3.9 Merced Irrigation District

> RE: Comments on the Draft Environmental Assessment/Proposed Finding of No Significant Impact Under NEPA and Notice of Availability and Intent to Adopt an Initial Study/Draft Mitigated Negative Declaration Under CEQA for the Water Year 2010 Interim Flows Project, Dated June 3, 2009

3.10 San Joaquin River Exchange Contractors Water Authority

3.11 San Luis Canal Company

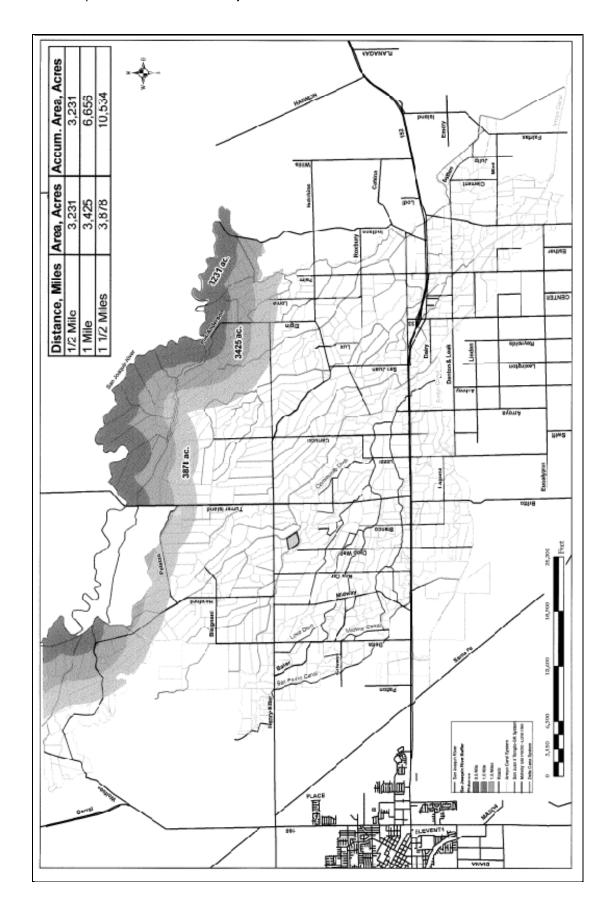
4. Reach 4B essentially has no capacity to transport water. SLCC owns a number of facilities in Reach 4B that could be affected by the Proposed Action. Reclamation must complete all mitigation before any water is released into this section of the river. A map designating the SLCC service area south of the River in Reach 4B is attached. This map designates the potential acres, and facility locations, that could be influenced and need mitigation. There are three different acreage estimates based on how far potential issues arise from the Rivers edge.

SLCC-4: The areas identified on the attached map are within the study area evaluated for impacts in the Draft EA/IS. The Proposed Action does not include conveyance of WY 2010 Interim Flows through Reach 4B1; therefore, no impacts are identified and no mitigation measures are required in Reach 4B1. The Proposed Action includes routing of WY 2010 Interim Flows through Reach 4B2. The map provided does not identify any areas of concern or facility locations in Reach 4B2. The analysis presented in the Draft Environmental Assessment/Initial Study did not identify potential impacts to facilities in Reach 4B2 (which has an estimated existing channel capacity of 4,500 cubic feet per second (cfs)). No revisions to the Draft EA/IS text were necessary in response to this comment; therefore, the EA/IS text was not modified.
